Below are responses to comments addressing the DRMS reclamation permit M-2024-005 for the Laster Gravel Pit operated by the Sedgwick County Road and Bridge Department. Attached to this response letter are the specific documents that were changed per the comments. These changes have been filed with the Sedgwick County Clerk and Recorder.

112 Reclamation Permit Application General Operation Information

ATTACHMENT 3
UPDATED RECLAMATION GRADE MAP

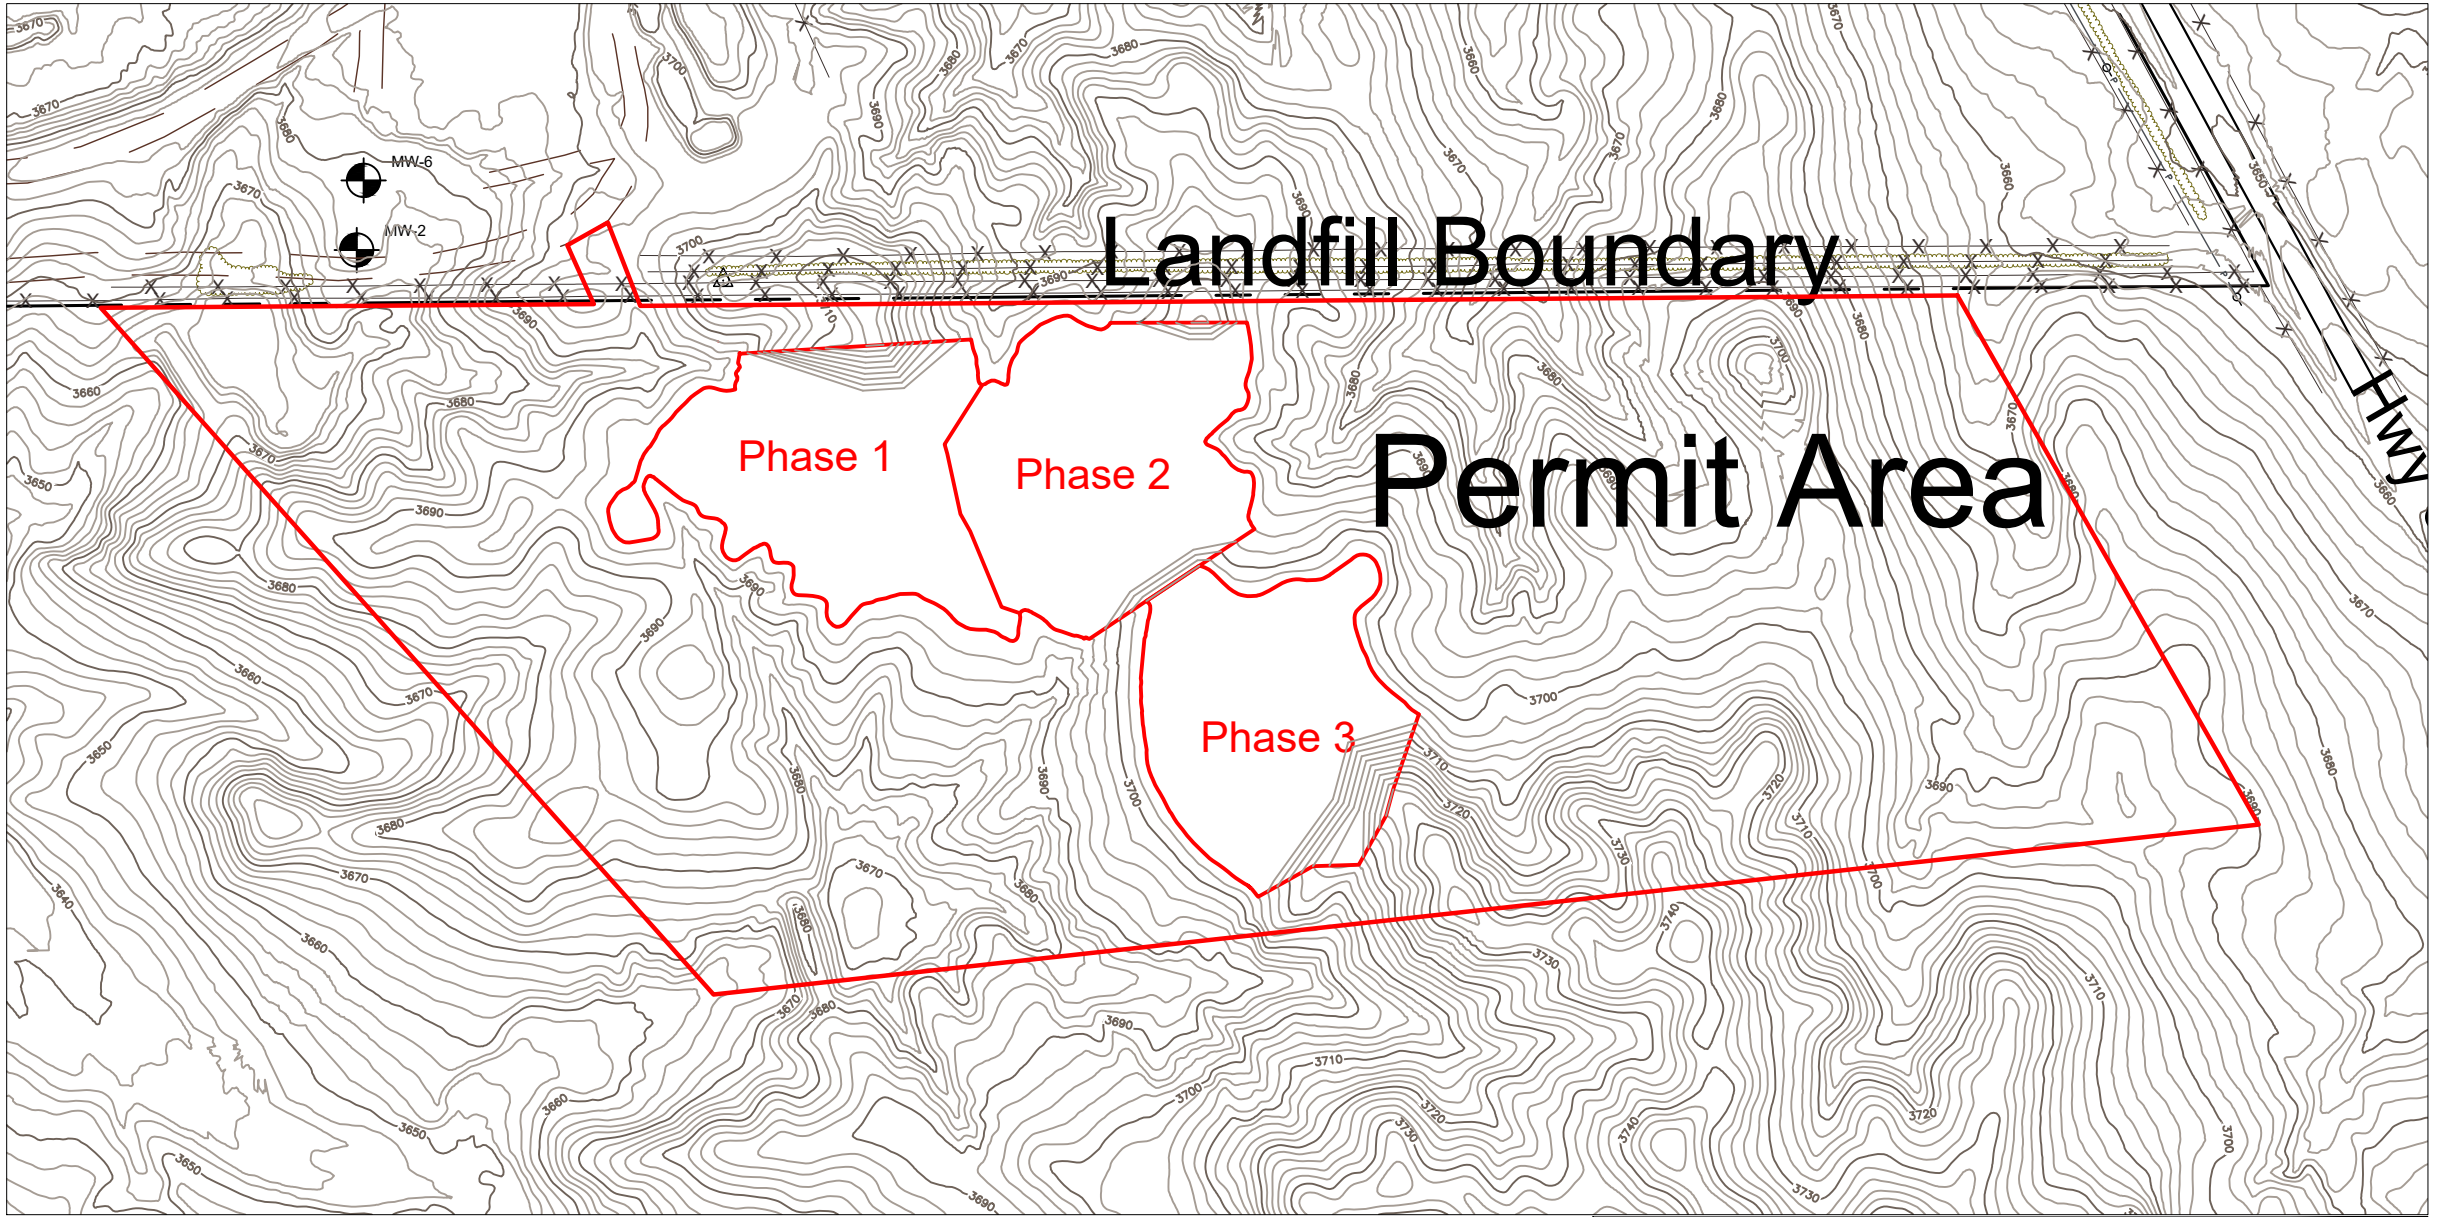
2. Rule 6.4.4(c) requires information about all water diversions and impoundments. There are three proposed sedimentation ponds shown on the map titled “Sedimentation Pond Locations”. During the per-operation inspection, it was observed that the two proposed sedimentation to the west have pre-existing berms to retain water. Clearly indicate that these two berms are pre-existing in the Mining Plan and state whether they will remain or be reclaimed during the reclamation operation. The settling pond located in the northeast area of the permit does not appear to have an existing retention berm. Provide information about the proposed construction and reclamation of the retention berm(s) that may be constructed for the retention pond located in the northeast portion of the permit boundary.

3. The current map submitted showing the expected physical appearance of the affected land does not include all the affected areas depicted in other maps, specifically the road and the settling ponds. Please submit an updated reclamation plan map that includes all the affected lands, in accordance with Rule 6.4.6(a), and that portrays the proposed final land use of the affected lands, in accordance with Rule 6.4.6(b).

Response: The water diversions and impoundments sections in the mining plan and reclamation plan sections have been updated to state that the pre-existing berms in the west ponds will be used for mining surface water controls and that these berms won’t be reclaimed after the mining has completed. These sections are also updated to include details on constructing a berm for the northeast pond. It is stated that this berm will be removed and reclaimed following mining completion. The updated mining and reclamation plans (Exhibits D,E) are included as Attachment 2 to this letter. The reclamation plan map now includes the ponds and is included as Attachment 3 to this letter.

Response: The permit area is updated in all maps to include the road from the landfill into the gravel pit operation. The reclamation plan map is updated to portray the final land use of the affected lands and include the settling ponds.

FINAL RECLAMATION GRADE	
LASTER PIT SEDGWICK COUNTY	
CLIENT: Sedgwick County	
PROJECT:	
PROJECT NO:	DATE COMPLETED: 10/19/2023
DESIGNED BY:	APPROVED BY:
DRAWN BY: RDS	DWG NAME:
REVISION:	REVISED BY: RDS DATE: 7/2/2024
1	UPDATED PER COMMENTS, PONDS/ROAD ADDED
AEC AMERICAN ENVIRONMENTAL CONSULTING, LLC.

ATTACHMENT 7
UPDATED ADJOINING SURFACE OWNERS MAP

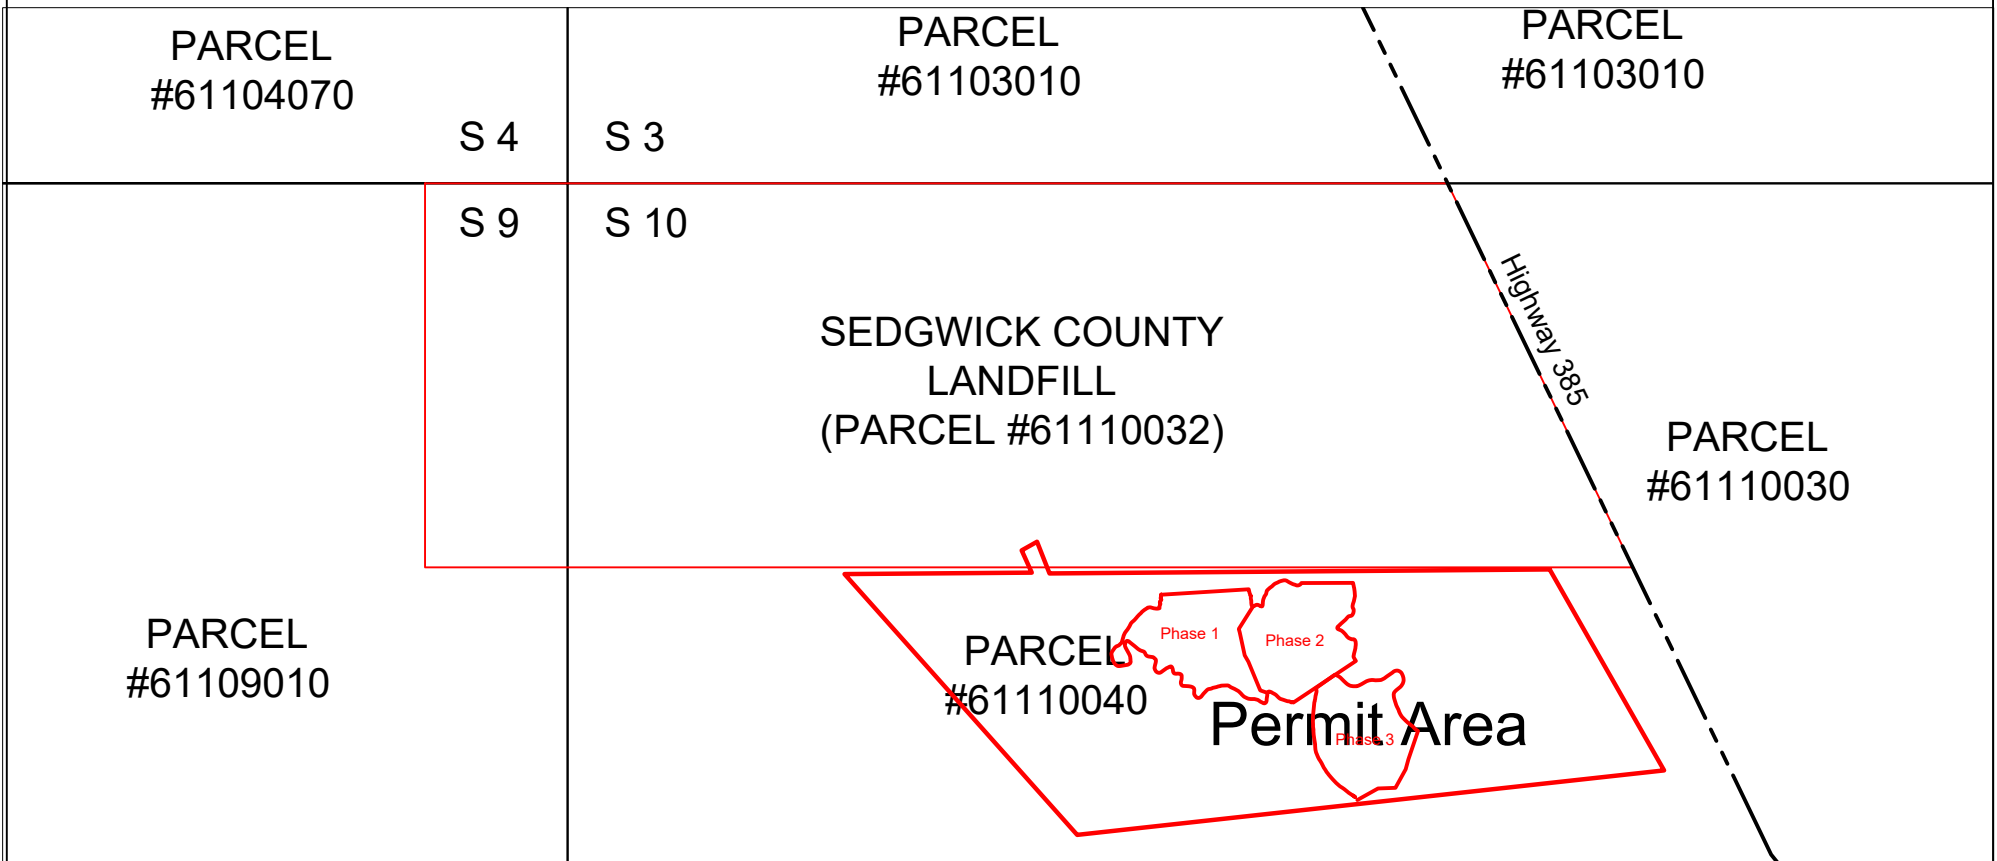
1. The provided proof of public notification in the Julesburg Advocate newspaper stated the operation name as “Laster Pit”. In the 112 Application Form, the operation name is given as “Sedgwick County Road and Bridge Laster Pit”. The Division will use the name given on the application form for all communications with the operator, necessary agencies, and the public. Please submit an updated 112 Application Form with the operation name “Laster Pit”.

Response: An updated page 1 of the application form with operation name changed to “Laster Pit” is included as Attachment 1 to this letter. An operation name updated performance warranty and affidavit of authority to execute performance warranty are currently being sent by Kasey Campbell. All maps were updated to have “Laster Pit” as the operation name and are included in Attachments 3-7 to this letter.

ADJOINING SURFACE OWNERS MAP			
LASTER PIT SEDGWICK COUNTY			
CLIENT: Sedgwick County		DATE COMPLETED: 10/19/2023	
PROJECT: Gravel Pit		APPROVED BY:	
PROJECT NO:		DWG NAME:	
DESIGNED BY:		REVISED BY: RDS	
DRAWN BY: RDS		DATE: 7/2/2024	
REVISION:			
1. UPDATED PER COMMENTS, ROAD ADDED
